ADDENDUM NO. 1 TO PROJECT NO. 47261

CONSTRUCTION WORK PROVIDE MASONRY REPAIRS, FAÇADE, BUILDING 40 CREEDMOOR PSYCHIATRIC CENTER 80-45 WINCHESTER BOULEVARD QUEENS VILLAGE, NY

January 9, 2026

DRAWING NUMBER:
A-574

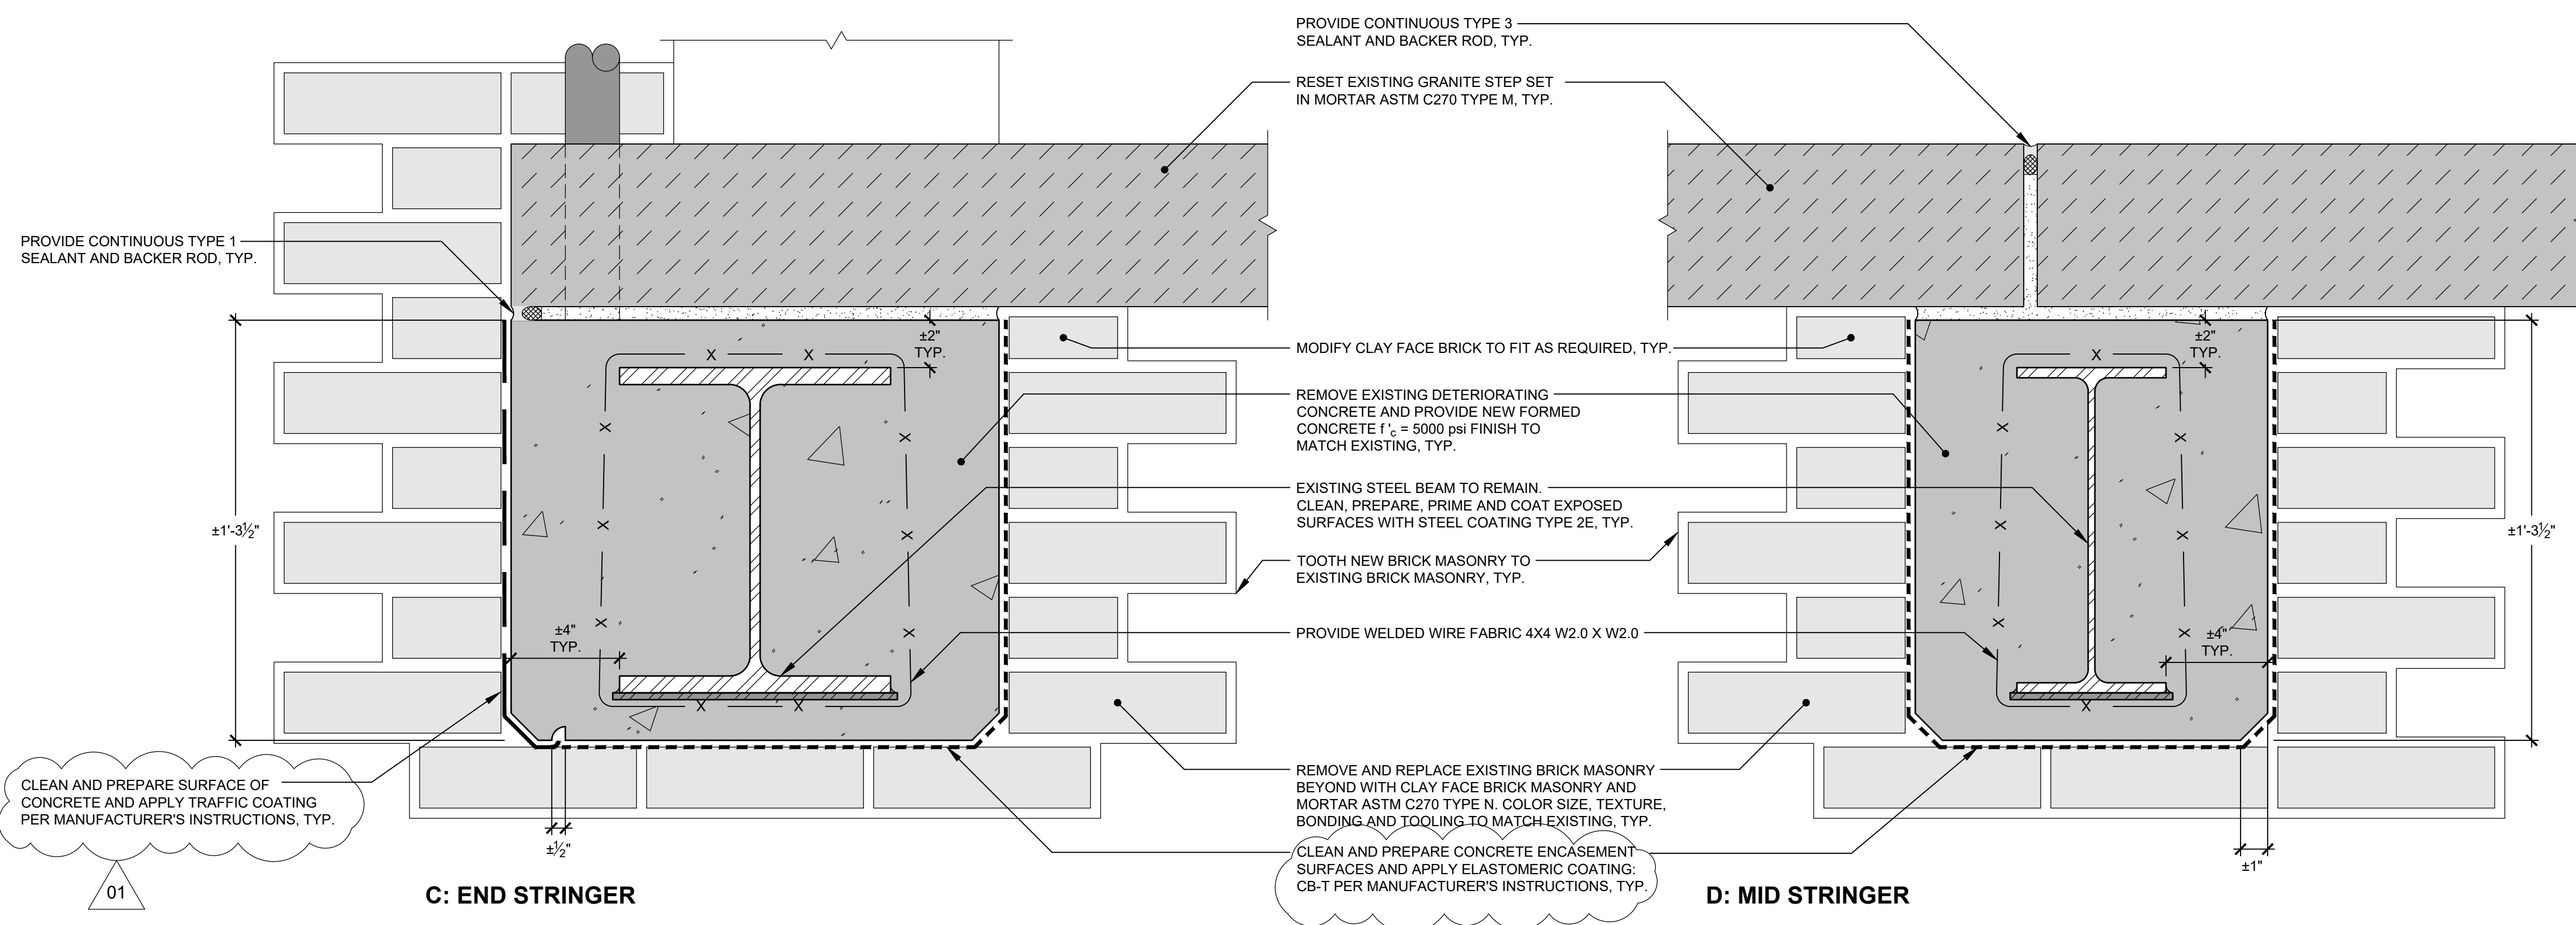
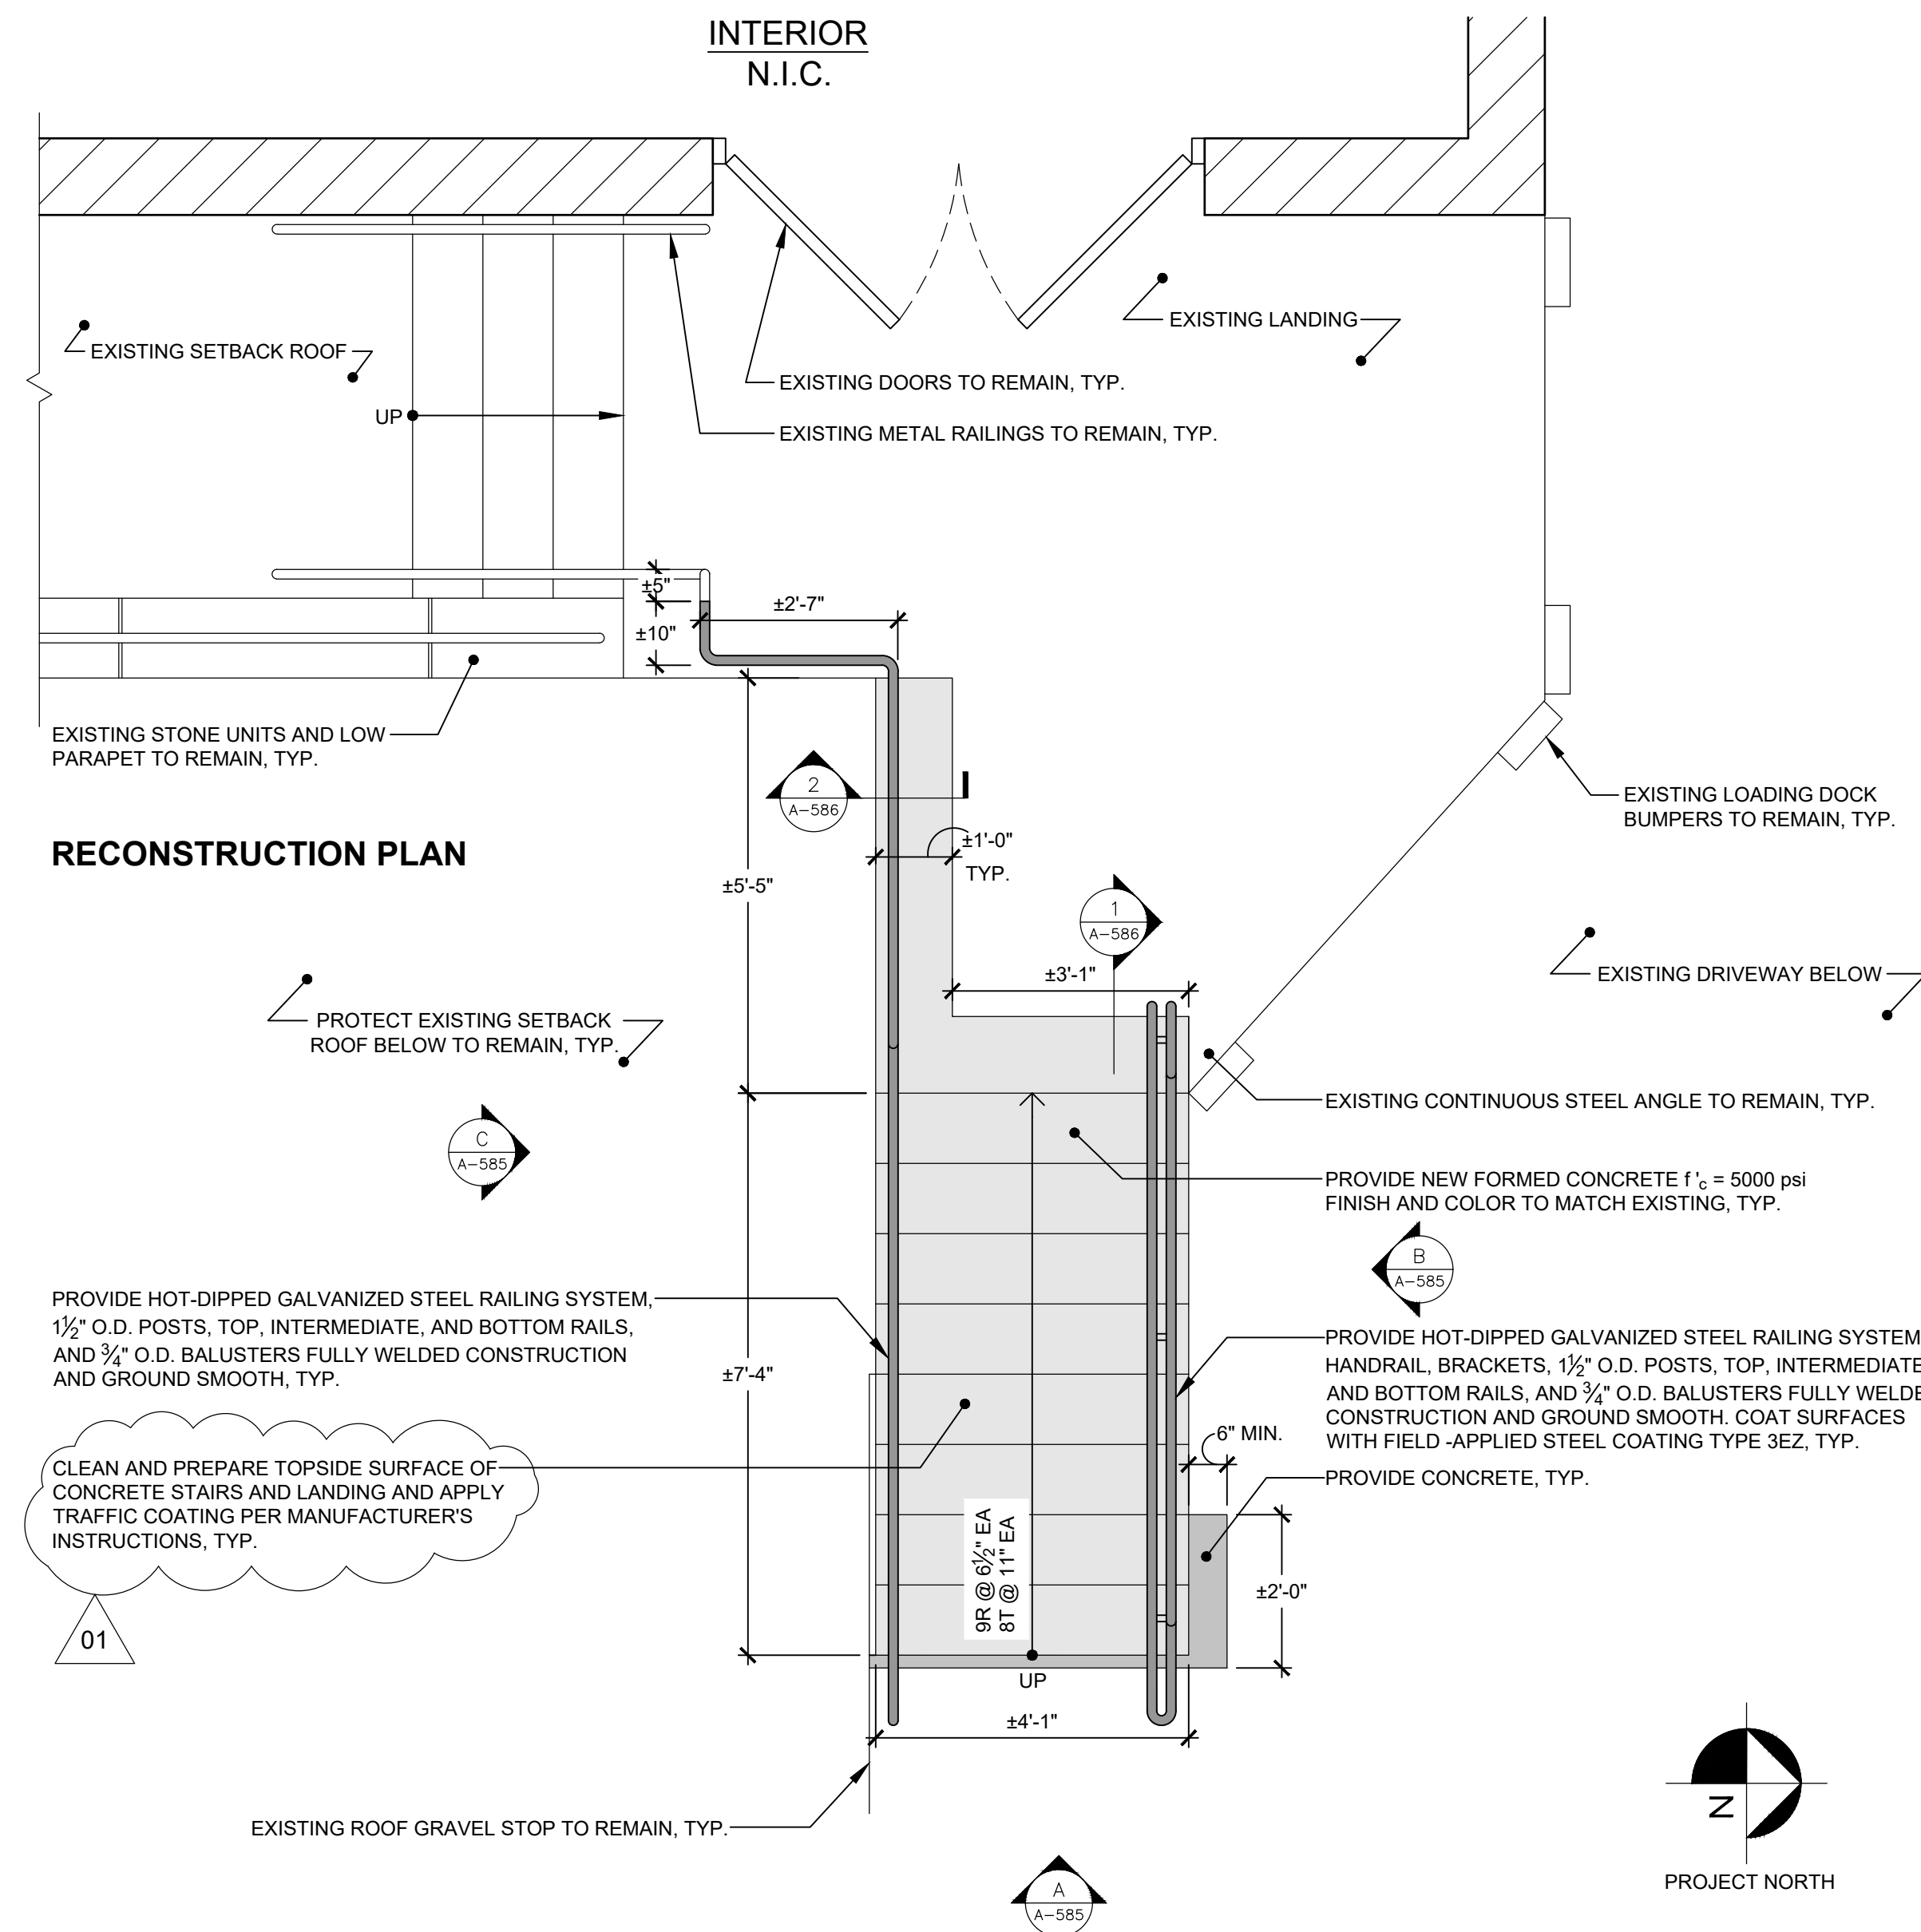
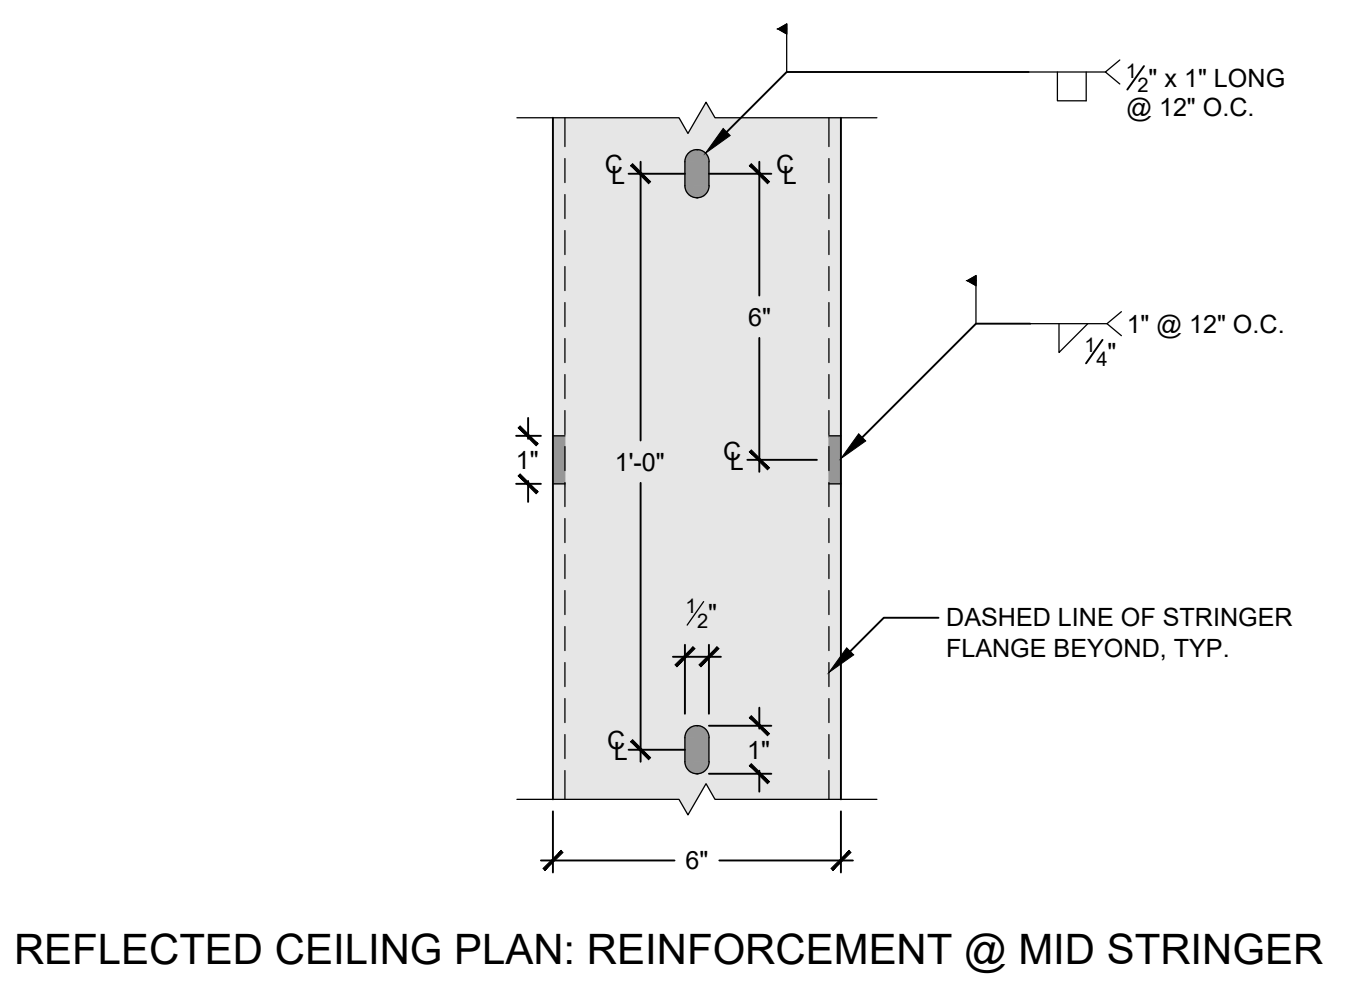
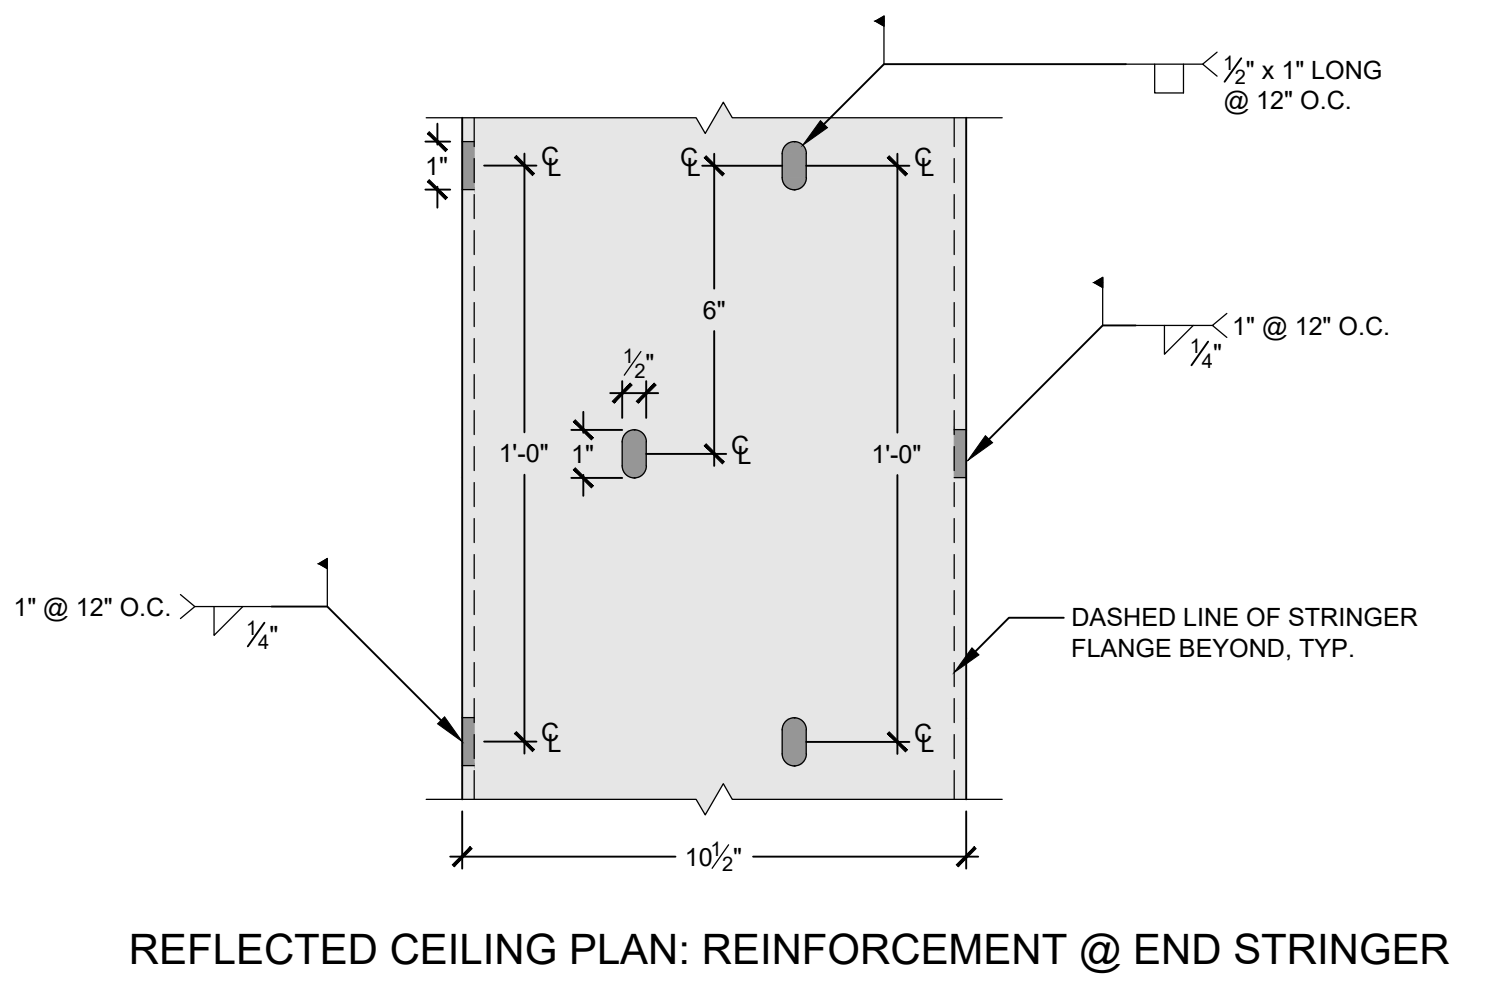
8. Drawing No. A-546
 - a. Included note of location of traffic coating application.
9. Drawing No. A-568
 - a. Included note of location of traffic coating application.
10. Drawing No. A-574
 - a. Included note of location of traffic coating application.
11. Drawing No. A-585
 - a. Included note of location of traffic coating application.
12. Drawing No. A-588
 - a. Included note of location of traffic coating application.
13. Drawing No. A-590
 - a. Included note of location of traffic coating application.
14. Drawing No. A-592
 - a. Included note of location of traffic coating application.

CLEAN AND PREPARE TOPSIDE SURFACE OF CONCRETE STAIRS AND LANDING AND APPLY TRAFFIC COATING PER MANUFACTURER'S INSTRUCTIONS, TYP.
